RE: **EM-AT&T-049-181031** – AT&T notice of intent to modify an existing telecommunications facility located at 77 Town Farm Road, Enfield, Connecticut.

RE: **EM-AT&T-049-181031** – AT&T notice of intent to modify an existing telecommunications facility located at 77 Town Farm Road, Enfield, Connecticut.

Please see the attached response to the notice of incomplete received on November 1, 2018, as well as the revised construction drawings reflecting the needed change.

AT&T notice of intent to modify an existing telecommunications facility located at 77
Town Farm Road, Enfield, Connecticut
AT&T Site Name: Enfield Town Farm Road
AT&T Site No.: CTL01021 / FA# 10034985

2 ENLARGED EQUIPMENT PLAN
 SCALE: AS NOTED

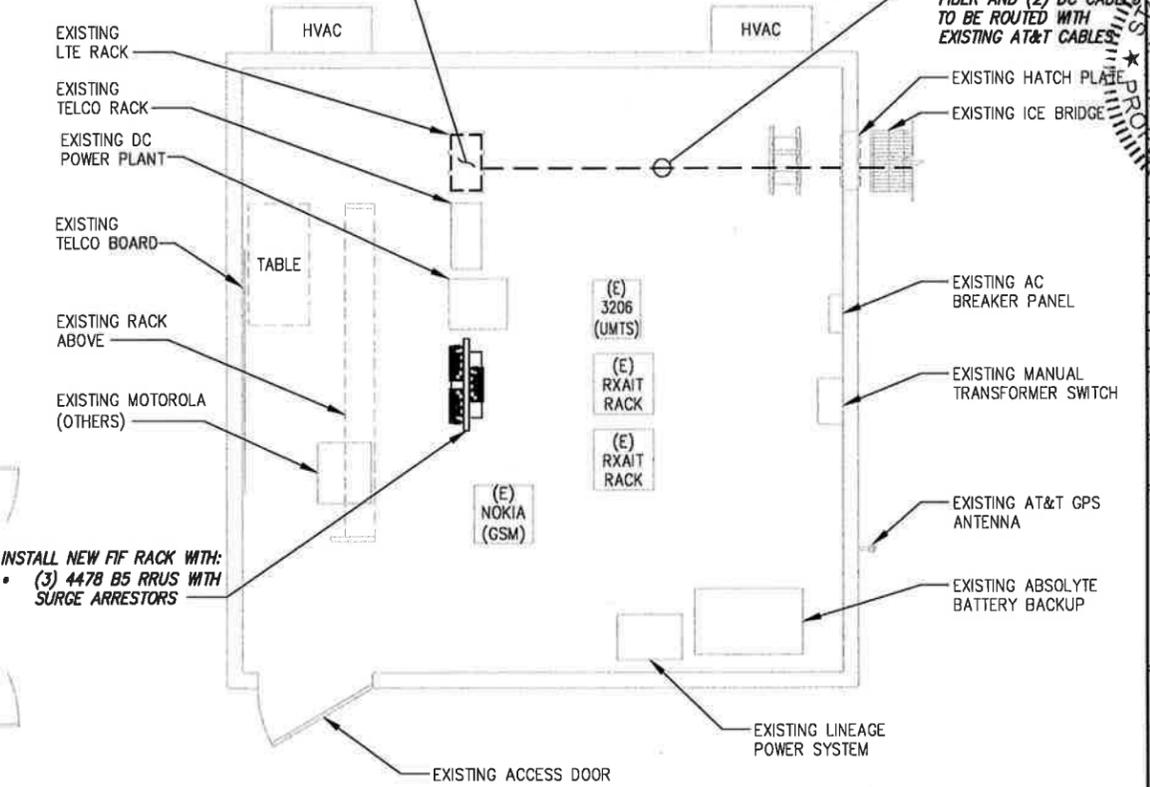
Staff has reviewed this exempt modification request for completeness and has identified inconsistencies with the proposed equipment schedule. The Structural Analysis Report provided is prepared by American Tower Corporation, dated July 11, 2018 and indicates the removal of six antennas and three remote radio units and the installation of six antennas and three remote radio units. The Construction Drawings prepared by Infinigy and dated October 17, 2018 indicates the removal of three antennas and three remote radio units, the relocation of three antennas, the installation of nine remote radio units and the installation of three antennas. The cover letter indicates the replacement of three antennas and the installation of six remote radio units. This is inconsistent and thus the extent of the proposed modification is unclear.

The construction drawings submitted as part of the filing produced by Infinigy, dated 10/17/2018 did have an error, as the RRUS 4478 B5 will be installed in the shelter, not on the tower. I have enclosed the revised drawings. The final scope of work for what will be installed on the tower will be the following:

- Remove (3) panel antennas
- Install (3) panel antennas
- Remove (3) RRUS-12 w/ A2 module
- Install (3) B25/B66A 8843 RRUS
- Install (3) RRUS-32
- Install (1) DC-6 Squid w/ (1) Fiber and (2) DC Cables
- Install (6) Low band combiners

INSTALL NEW FIF RACK WITH:
 • (3) 4478 B5 RRUS WITH SURGE ARRESTORS
